Addendum No. 2
August 30, 2024

Project: KOA – Rapid City Office
Rapid City, South Dakota
#3017

Architect: Architecture Incorporated

Scope of this Addendum:

TYPICAL FOUNDATION DRAIN DETAIL
Not To Scale

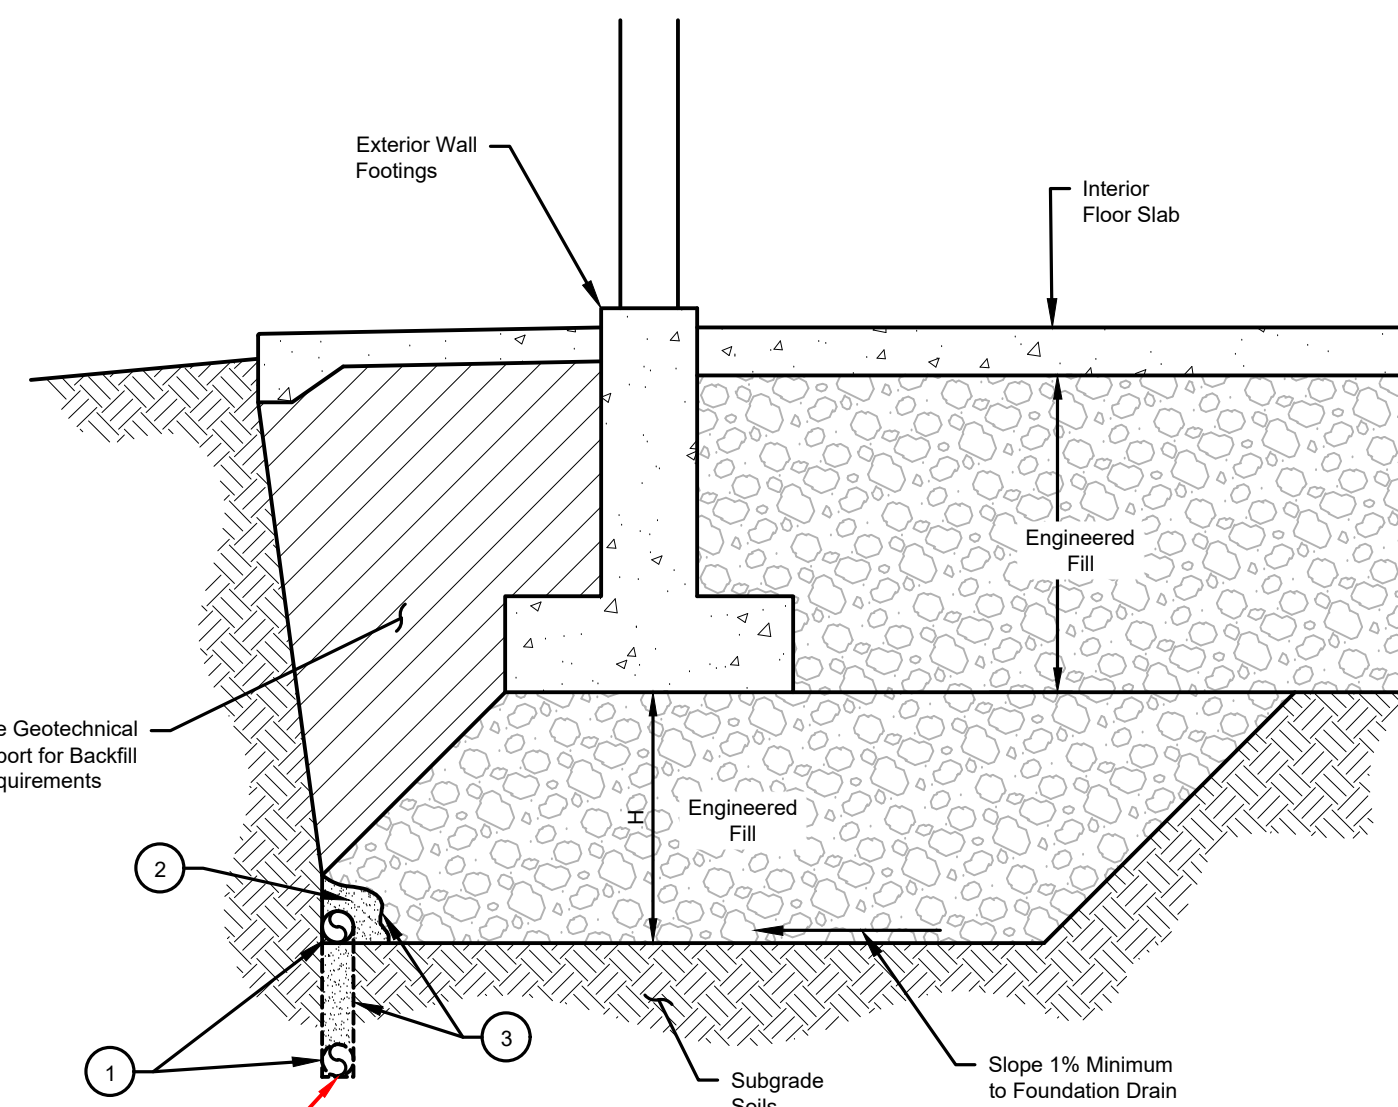
See revised drawings for changes to the water service line connection to the existing water main. has been changed. See
<u>Item</u> C2-4	<u>Description</u> SHEET 2.41 – Enlarged Grading Plan (Sheet Revision) Changes to the Spot elevations
	See revised drawings for changes to spot elevation along proposed wall and sidewalk.
<u>Item</u> C2-5	<u>Description</u> SHEET 2.75 – Details (Sheet Revision) Changes to the Details
	See revised drawings for changes to the following details:

- Typical Foundation Drain Detail
- Thickened Edge Sidewalk
- Reinforced Concrete Sidewalk
- 8" Gravel Surfacing

1
3.11
FND & FLR SLAB PLAN
SCALE: 1/8" = 1'-0"

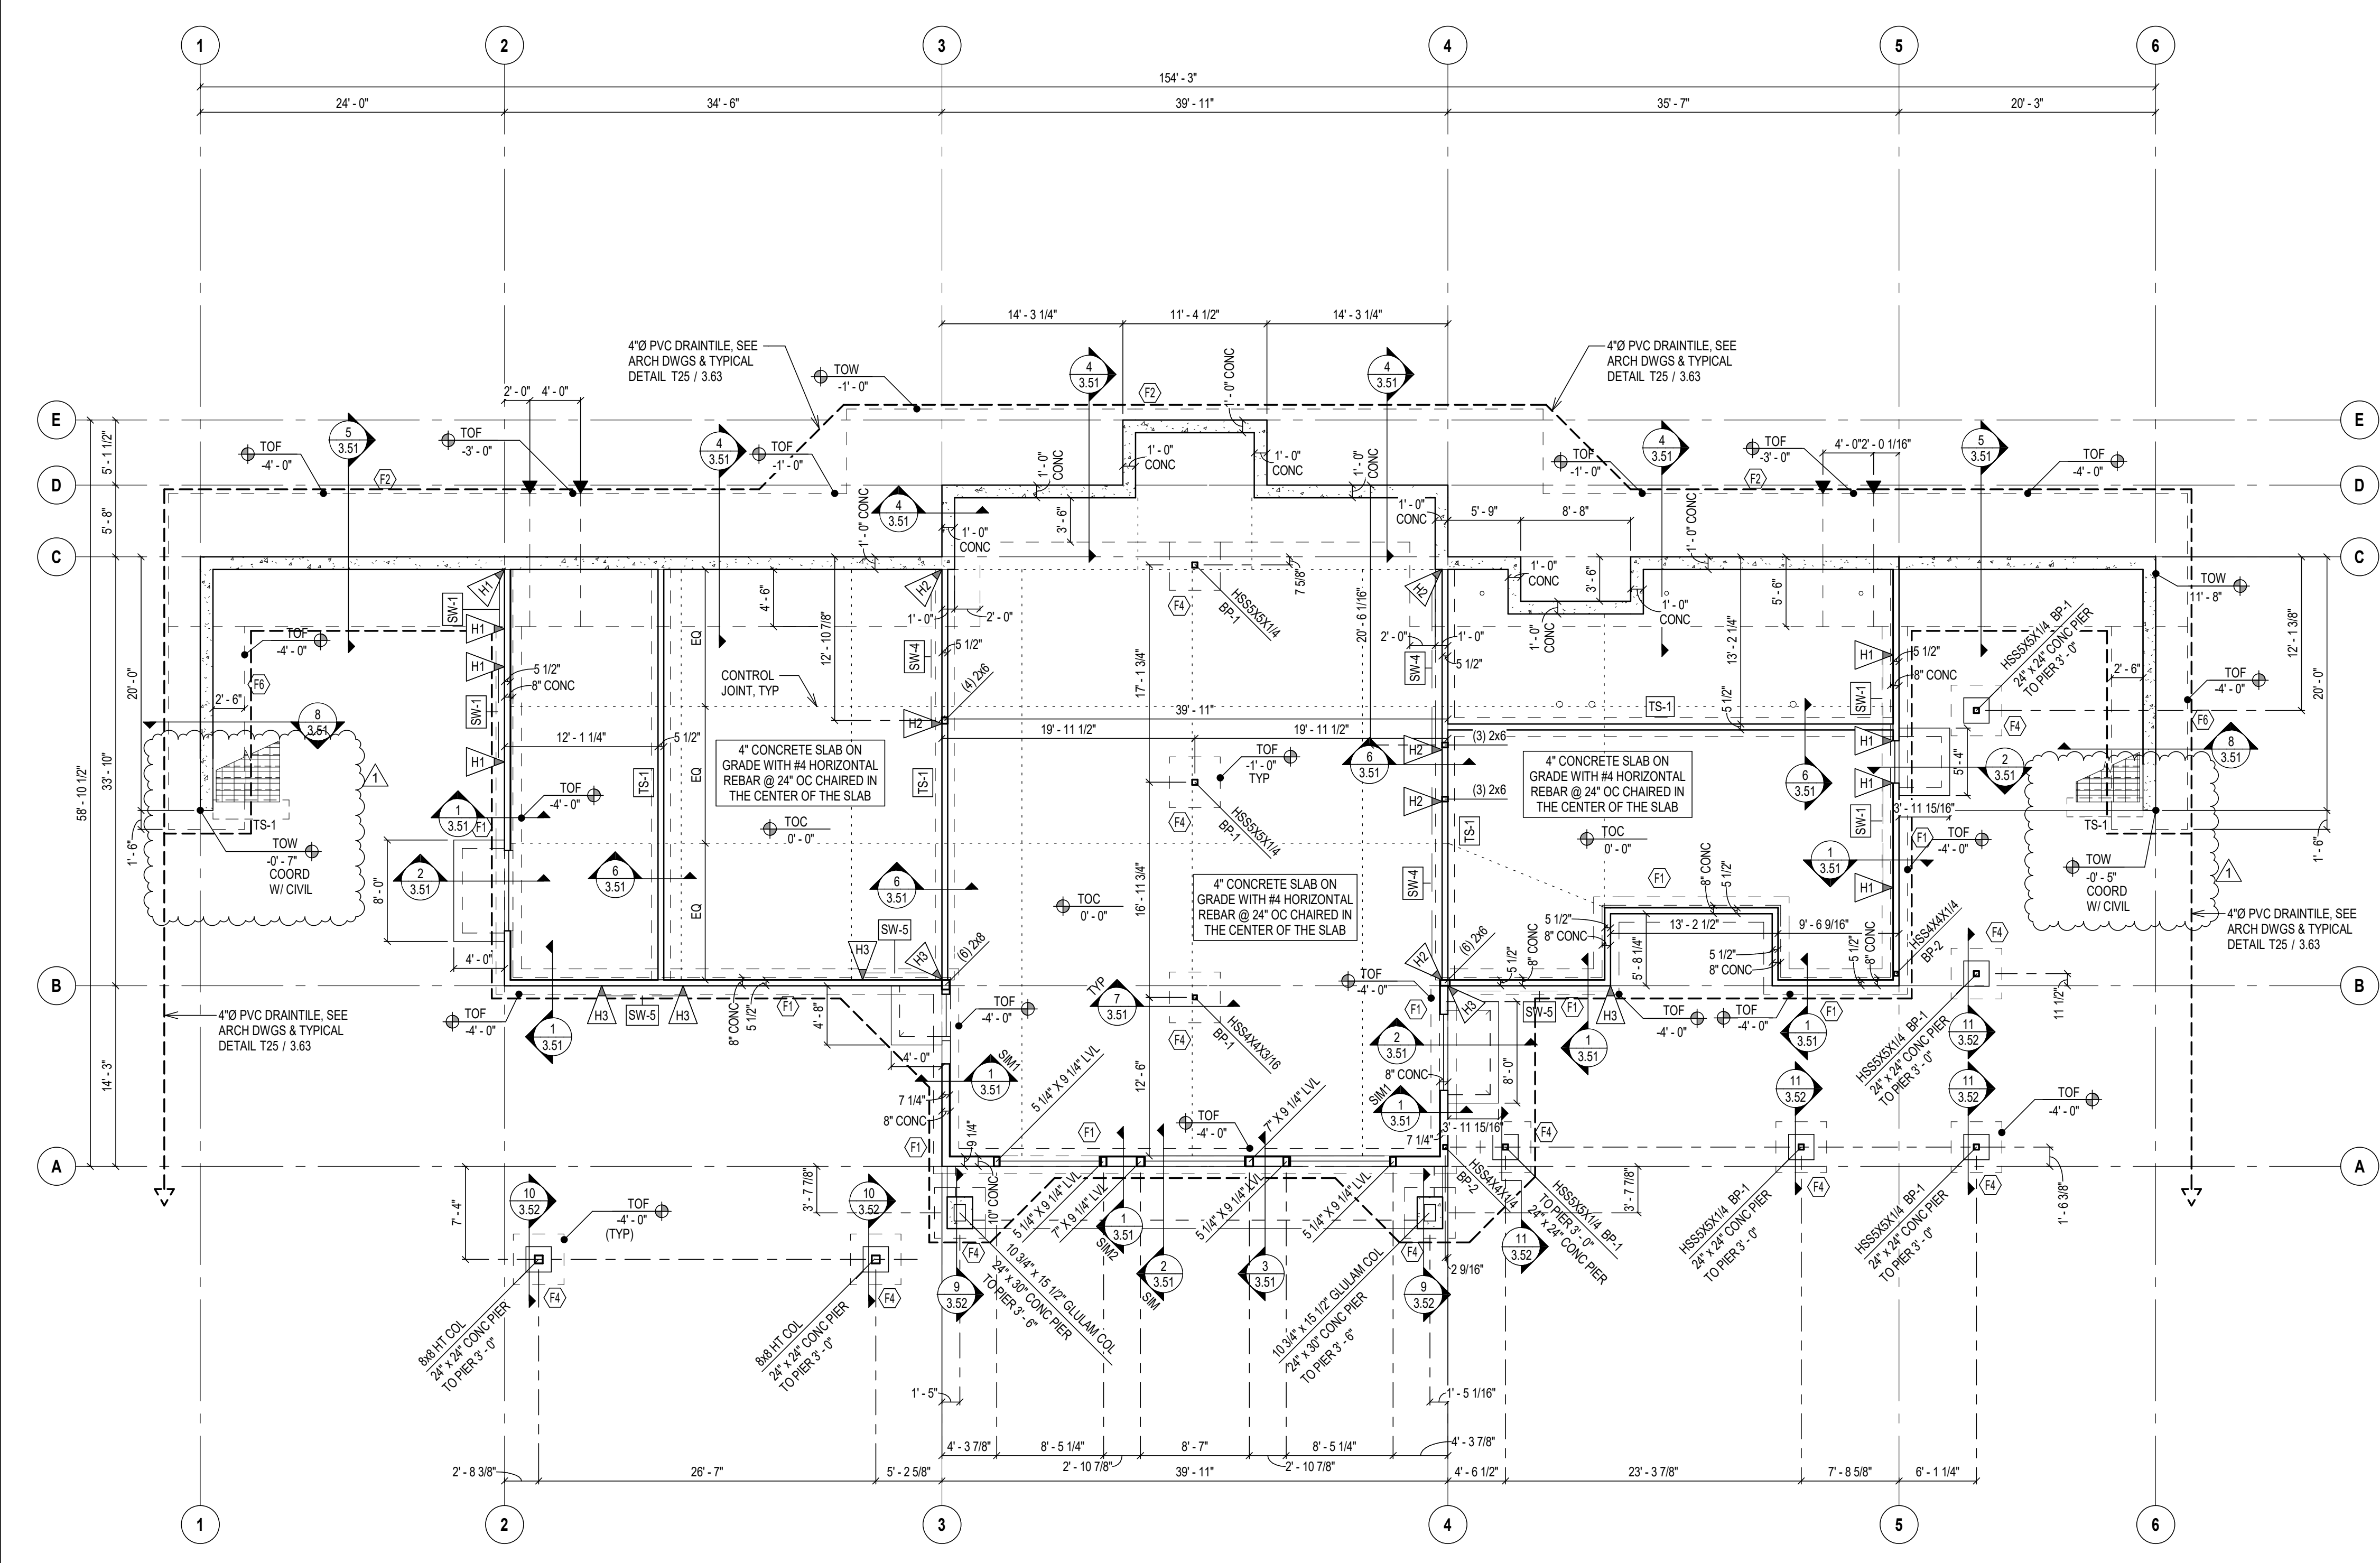
1. Elevations of top of concrete retaining walls outside of building slightly adjusted to better align with civil site elevations. Modifications made to sheets 3.11 and 3.12

F4
3.53

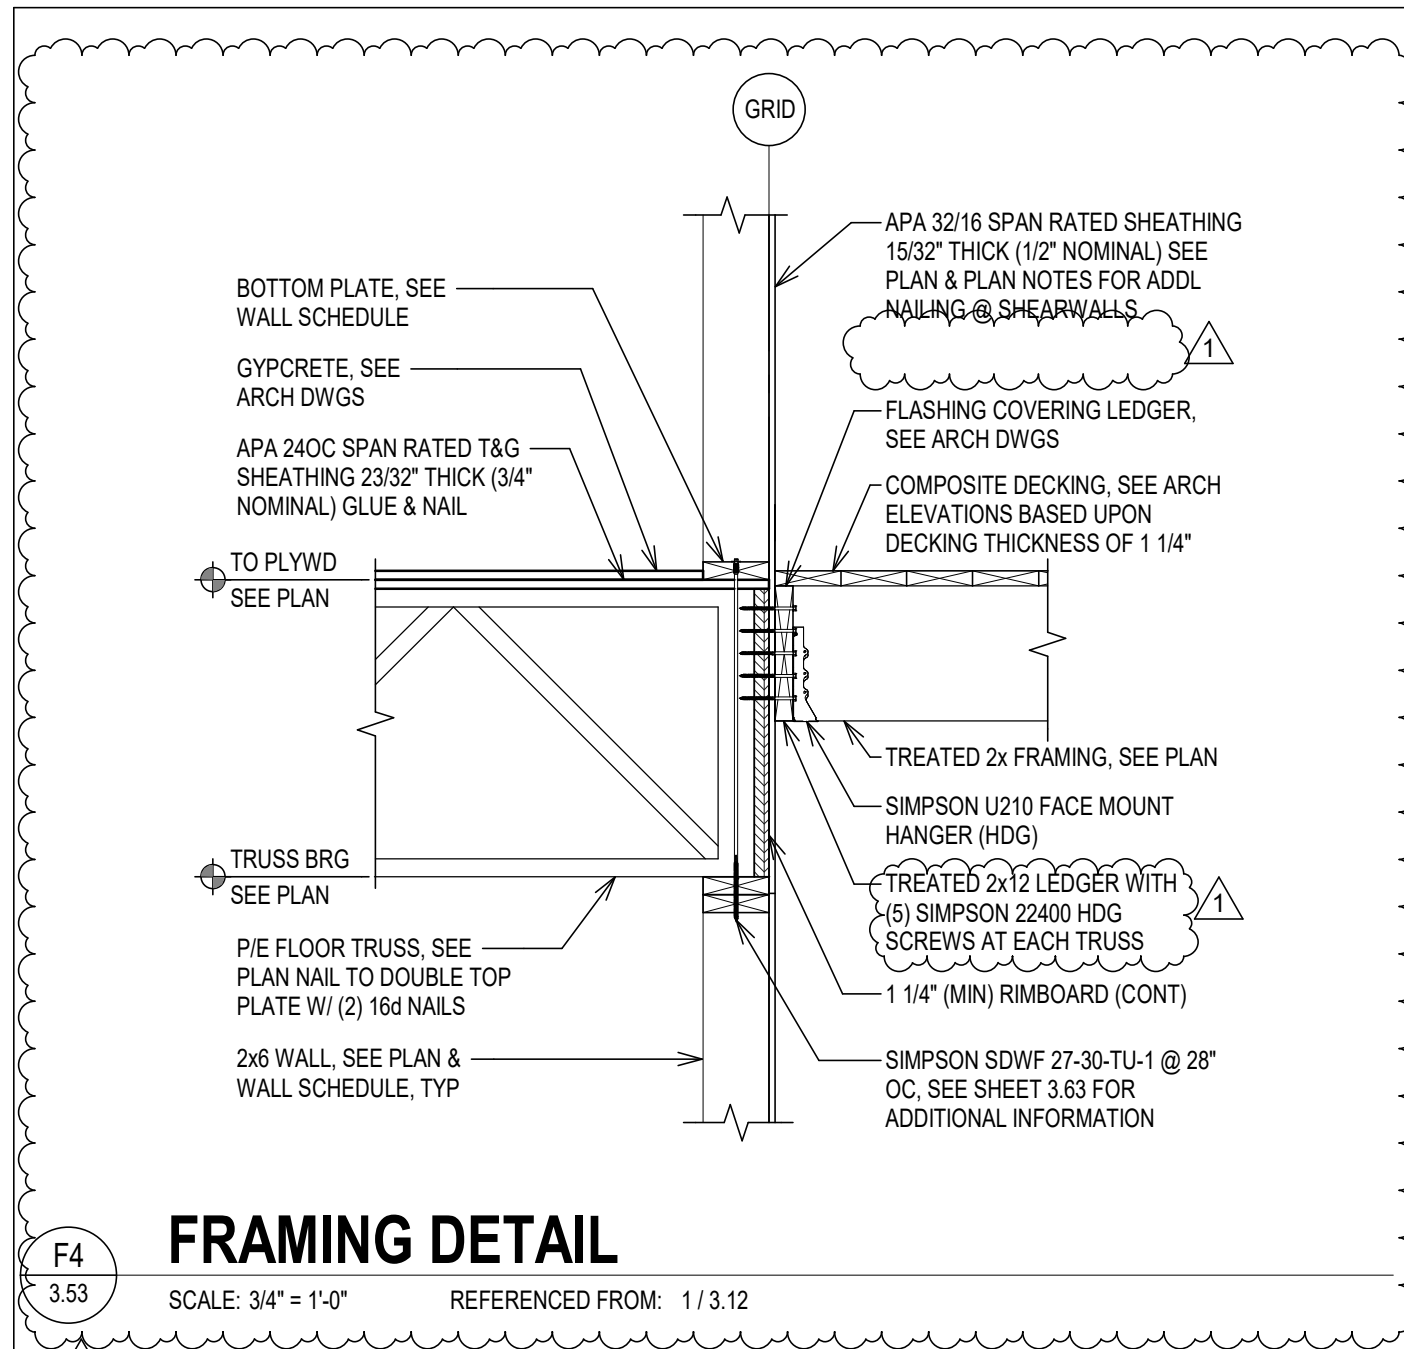
2. Ledger for deck called out to 2x10 on sheet 3.53 and should have been 2x12. Modifications made to sections F4, F6, and F12 of sheet 3.53
3. Drain tile shown on sheet 3.61 is singular, two drain tiles are not shown, nor intended. Geotech report shows two locations to depict varying elevation. It is to have positive slope to outlet. No change to documents required.
